# Access Compliance Report

## Public Rights-of-Way

### (Curb Ramps)

Intersection ID: 52467	Main Street: ACQUINAS_PL	Cross Street: ST_JOHN_LN	Location: W
ADA ID: B59F58DFA1CC	Ramp Type: BlendTrans1	Initial Pass/Fail: Fail	Overall Compliance: No
Severity Score: 12.5			
Codes/Mitigation Info/Possible Solution		Field Measurements/Component Compliance

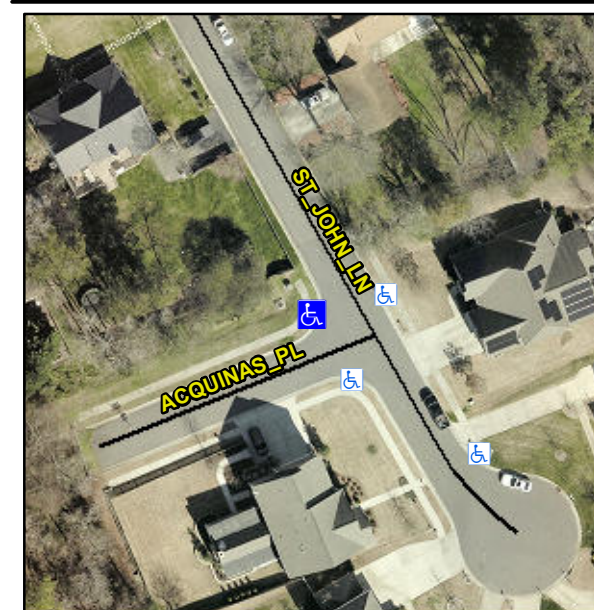
**Remove & Replace Curb Ramp With Two New Directional Ramps or Equivalent.**

**Not Found, R304.5.3**
